City of Placerville Planning Commission **STAFF REPORT**

APPLICATION NO.:	Site Plan Review 16-02 & Variance 16-01
DATE:	January 17, 2017
REQUEST:	Site Plan Review Approval for a 112 room hotel (Hampton Inn and Suites) and Variance request for building height.
STAFF:	Pierre Rivas, Director
<hr/>	
APPLICANT/OWNER:	All Four One, LLC
AGENT:	Brad Whitaker, Wasach Growth Partners – GHD, Inc. (Blake Johnson).
LOCATION:	3001 Jacquier Rd, northeast corner of Point View Drive and Highway 50, APN: 048:290:42
GENERAL PLAN:	Highway Commercial designation
ZONING:	Highway Commercial – Airport Overlay (HWC - AO)
PARCEL AREA:	3.01 acres
CURRENT USE:	Vacant – suspended construction on a 102-117 room hotel (Holiday Inn Express).
SURROUNDING USES:	North – Rural Residential; West – Single & Multi-Family Residential; South – Highway 50; East – Mixed Residential & Commercial (Smith Flat)
REQUIRED SETBACKS:	None
RECOMMENDATION:	Adopt findings and approve Site Plan Review 16-02 for a 112 room hotel (Hampton Inn and Suites); and adopt findings and approve Variance 16-01 for building height allowing for a maximum average height of 55 feet.

AS1.0

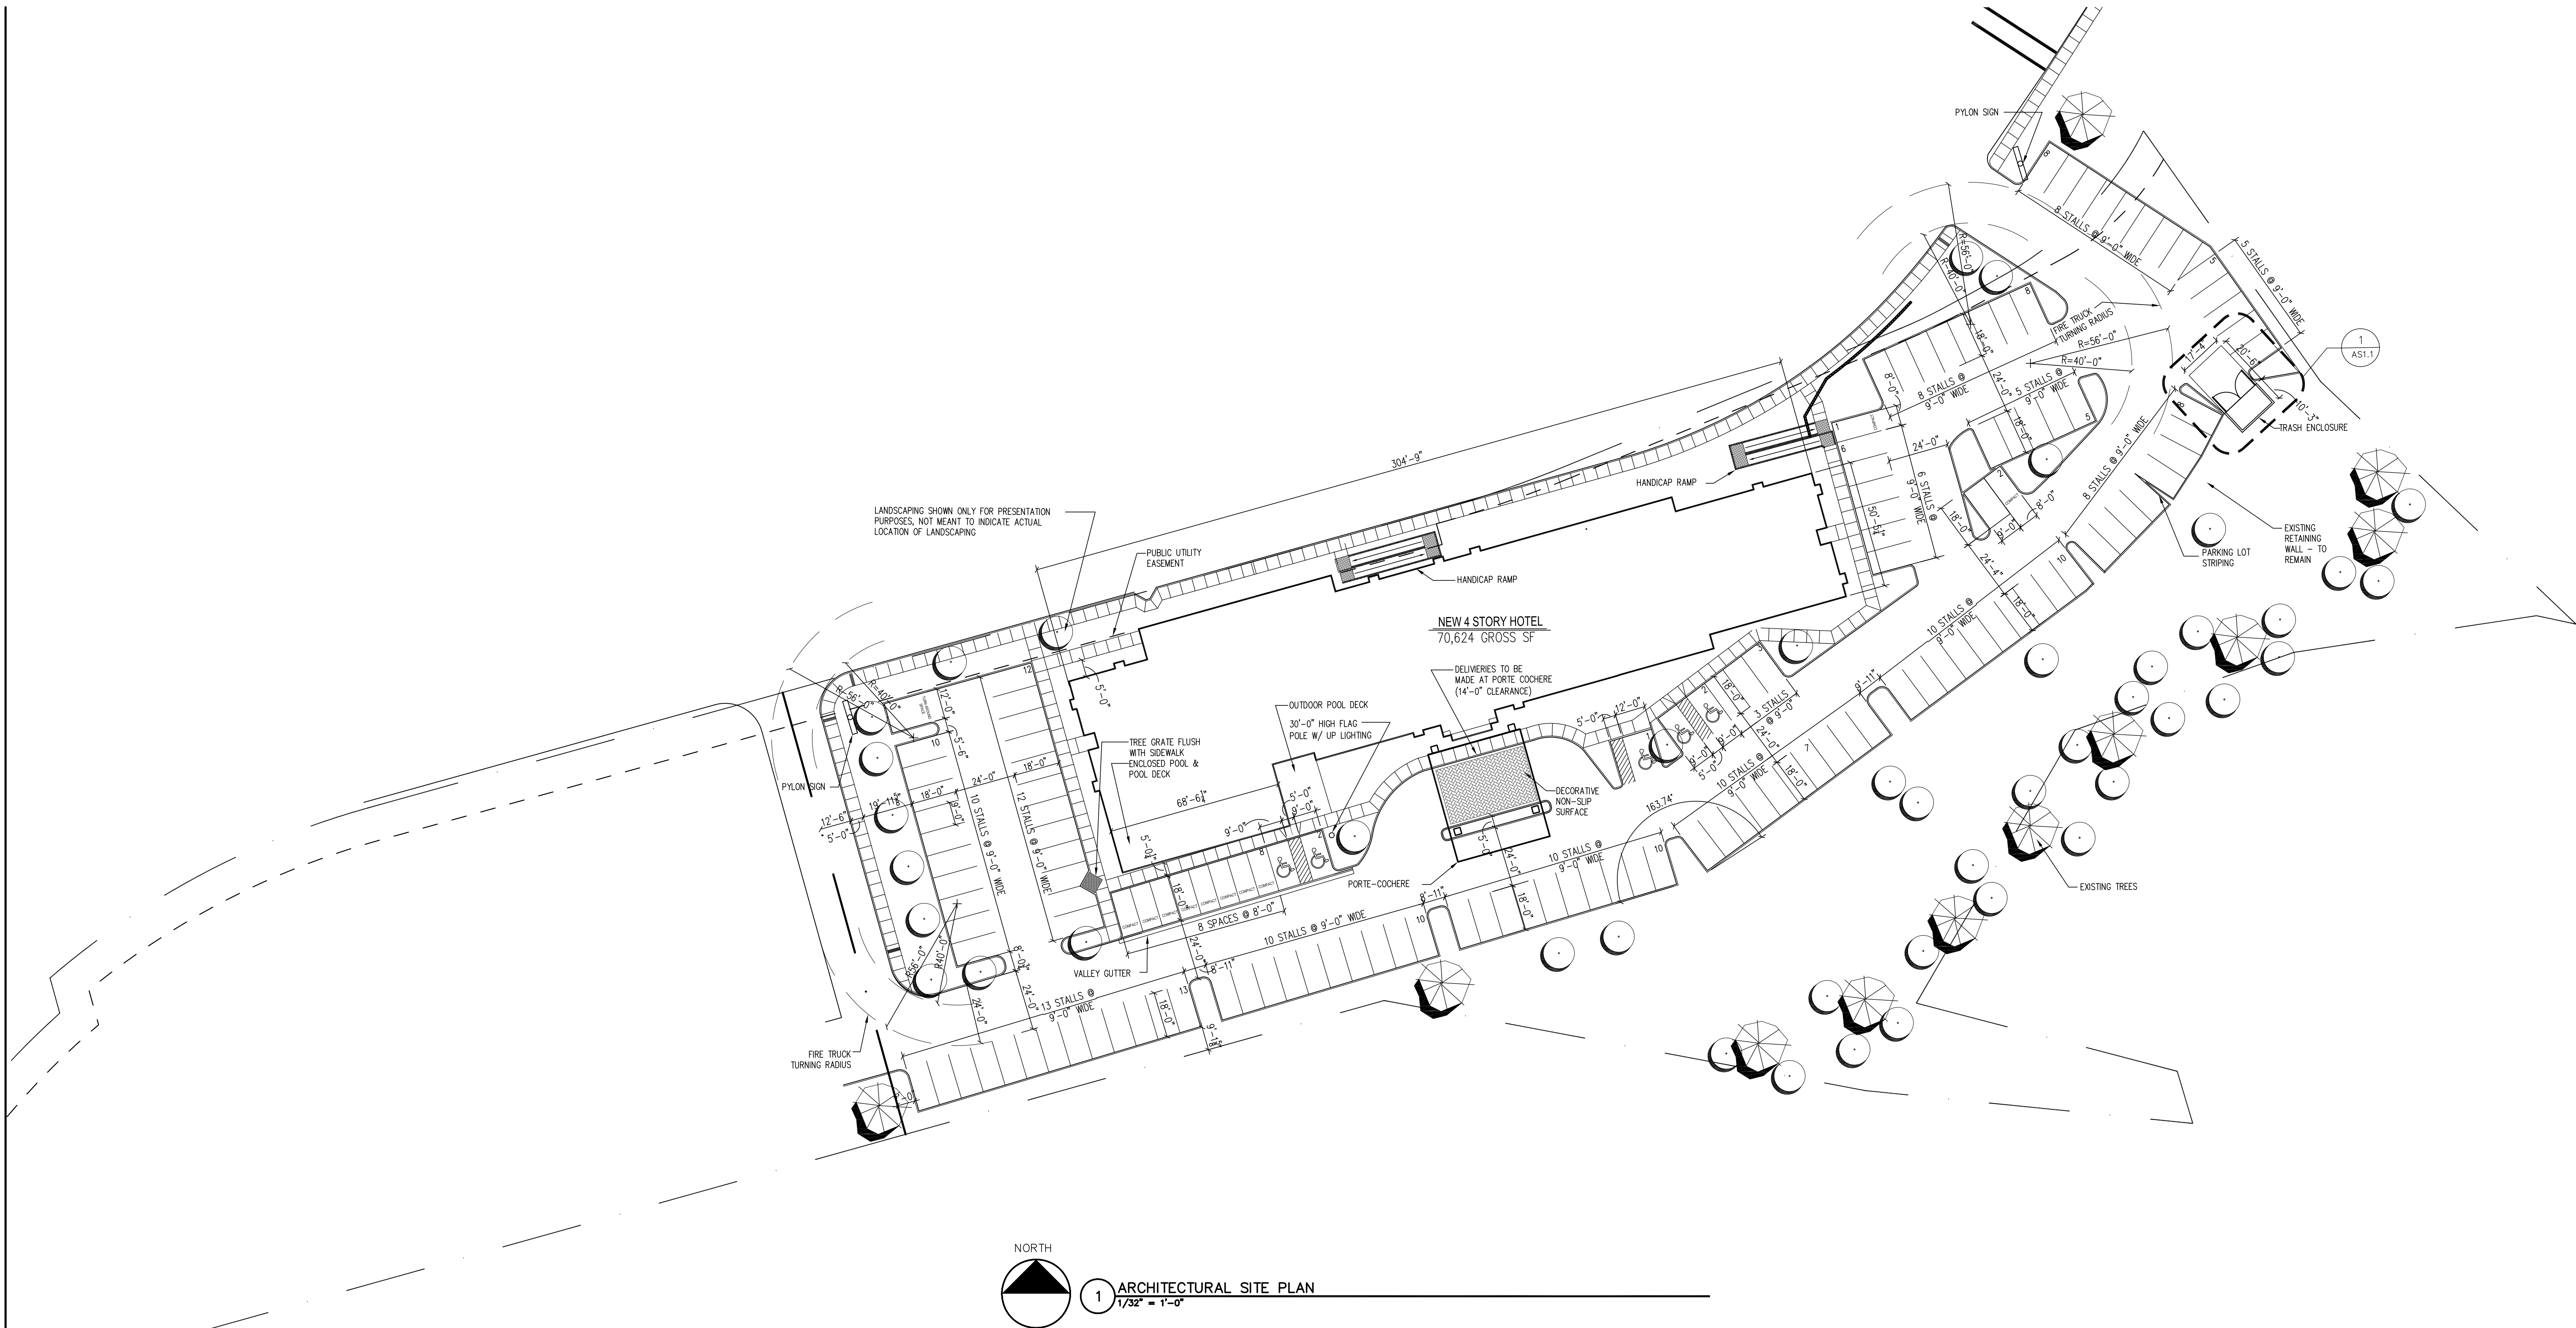
There are areas where the Preliminary Landscape Plan is deficient in detail that must be addressed in a Final Plan submittal. First, there are several areas in the parking area that do not meet the threshold for planters at 10 stall intervals. Secondly, the location of ground-mounted electromechanical equipment that supports ground floor services is not shown on the plan. Most of the equipment will be placed in the western half of the hotel given the floor plan. A reconnaissance of the Folsom hotel confirmed this issue. A Condition of Approval addresses this issue that requires a combination of physical and landscape screening subject to approval by staff.

- ii. The Landscape/Site plan shall be modified to include two additional parking lot landscaping strips as discussed herein subject to review and approval by staff.

Sheet No.
E001

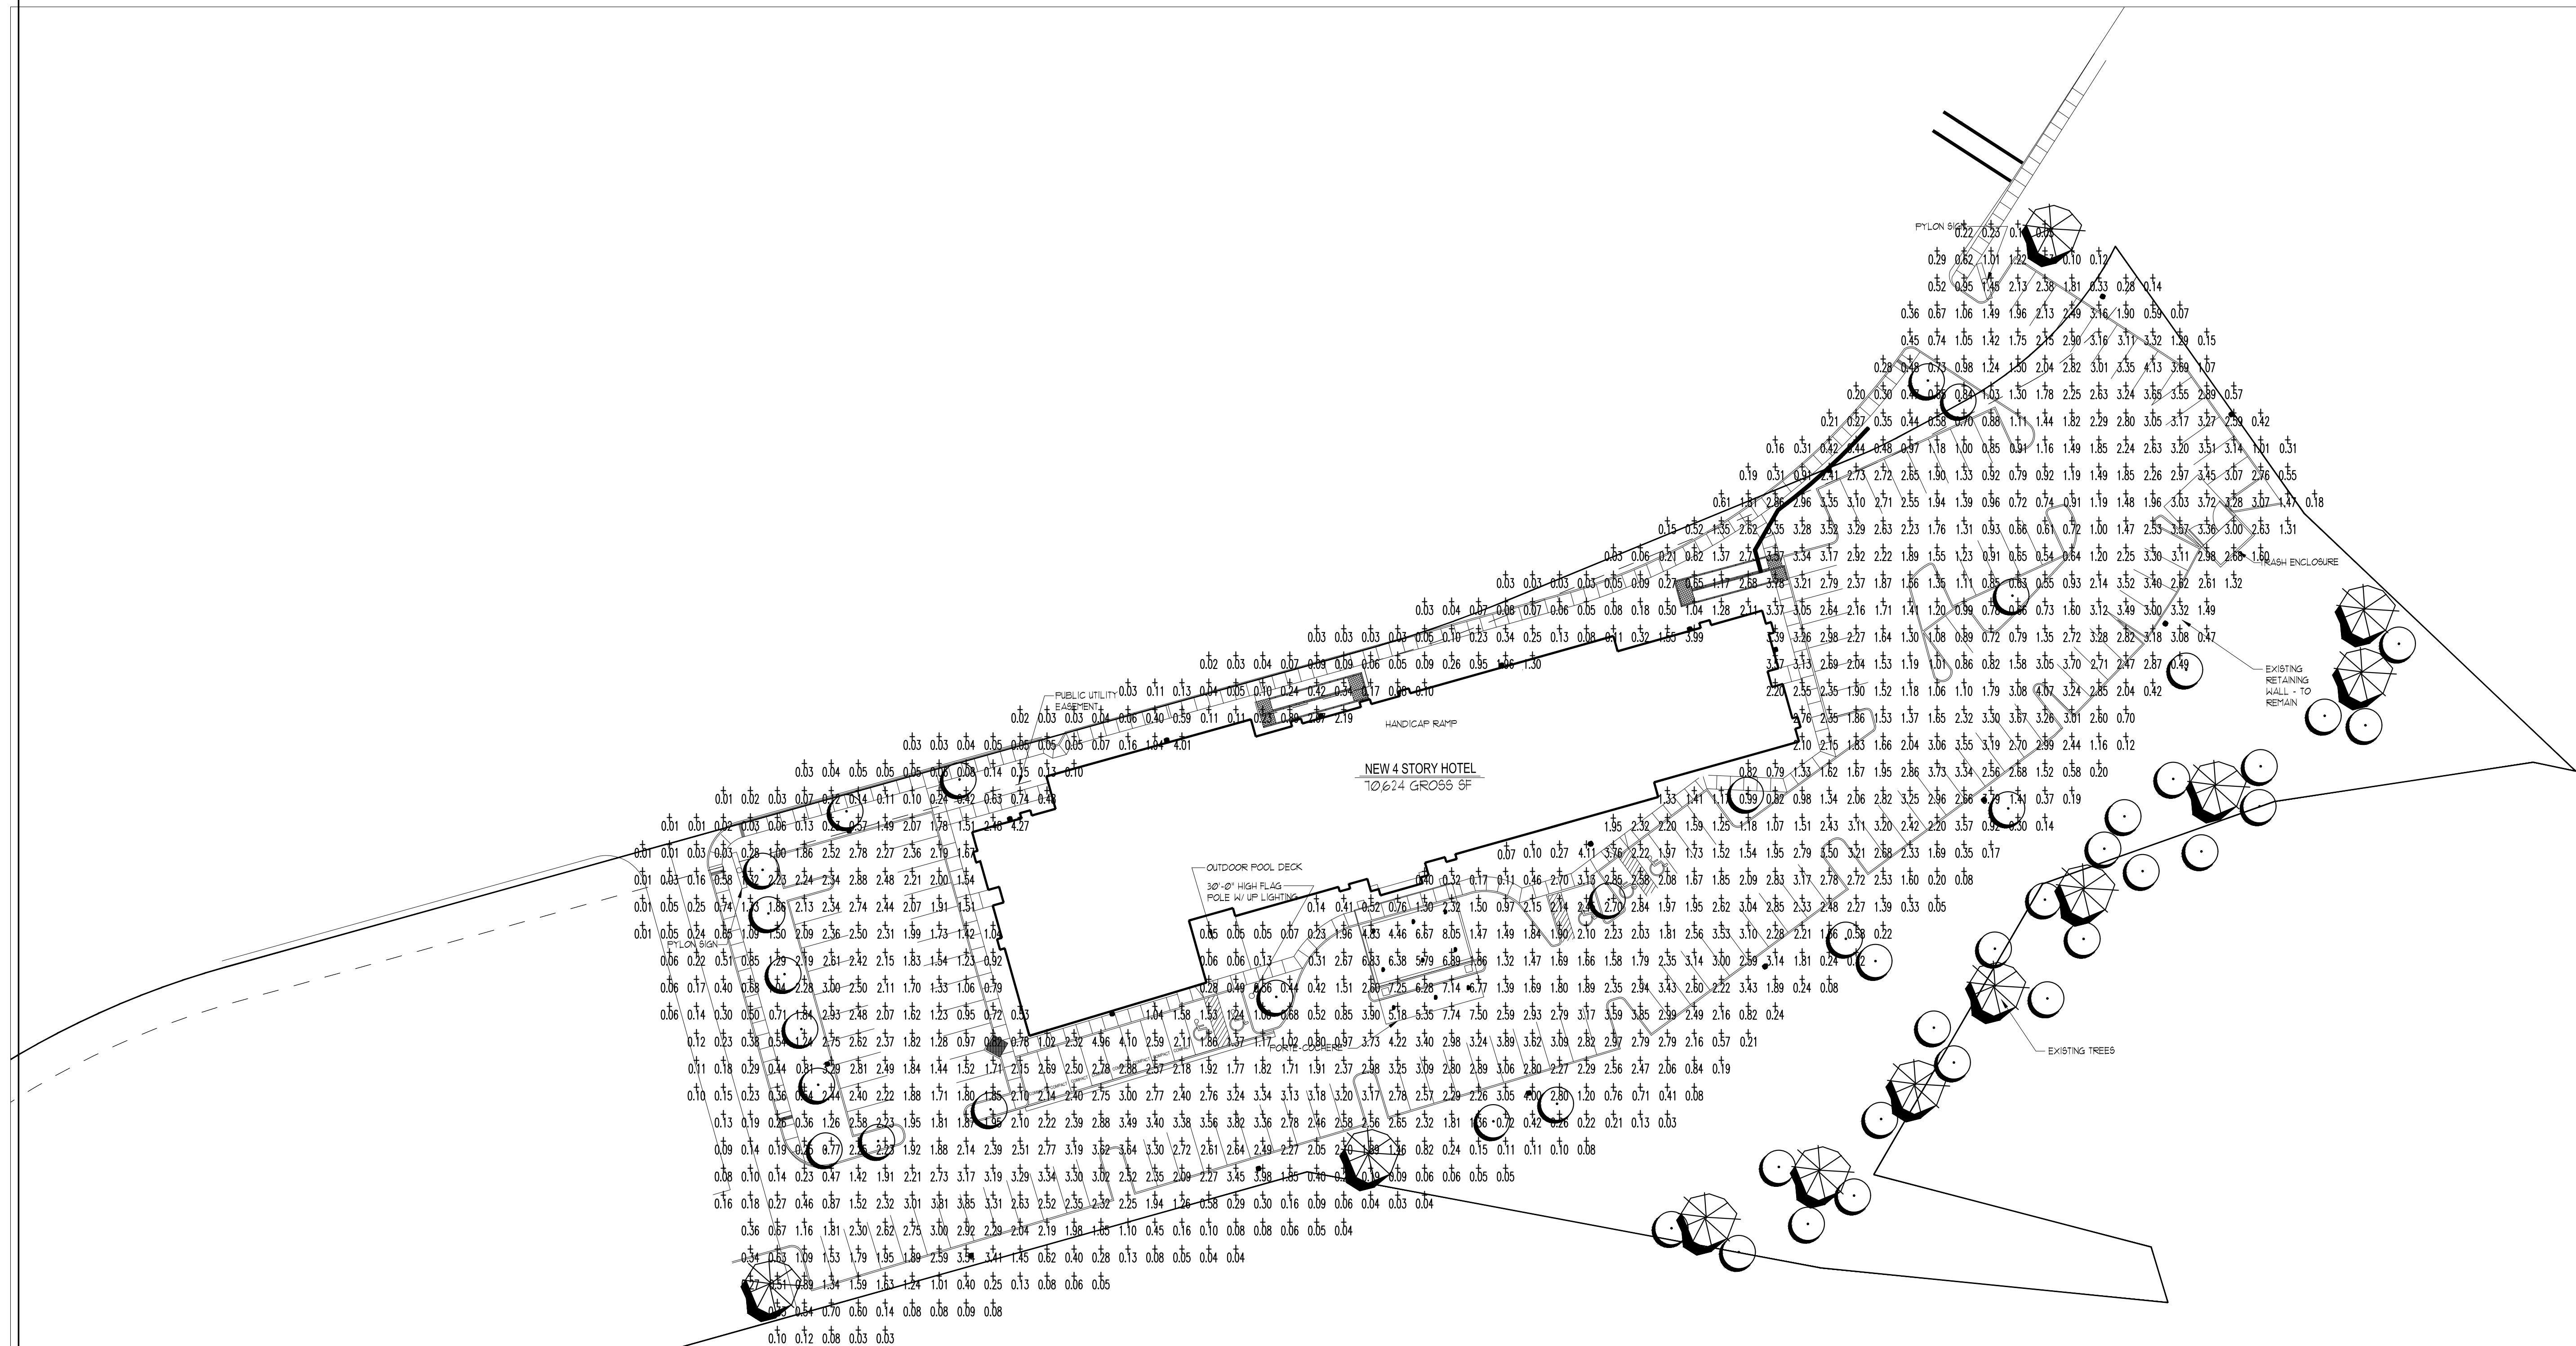
Exterior lighting for the hotel site generally consists of three types of lighting which includes: under-canopy lighting; wall mounted fixture (wal-pak) on the north (street) elevation, and 25' tall parking lot fixtures. The specifications of each fixture are shown on Sheet E002. Staff has reviewed the exterior lighting plan and accompanying photometric analysis and concludes that the proposed exterior lighting complies with the prescriptive criteria set forth in code in terms of complying with meeting light trespass at property lines, meeting minimum lighting levels for walkways and parking area, and pole light height standards. Staff notes that the "wal-pak" lighting on the north elevation is architecturally inappropriate and should be substituted with the decorative fixture show on sheet E002 as Option 2. A condition of approval to this issue is incorporated herein.

- vi. The proposed “wall-pack” light fixtures as shown in the lighting plan are not permitted. Applicant shall submit alternative light fixtures to the Planning Division for staff review and approval.
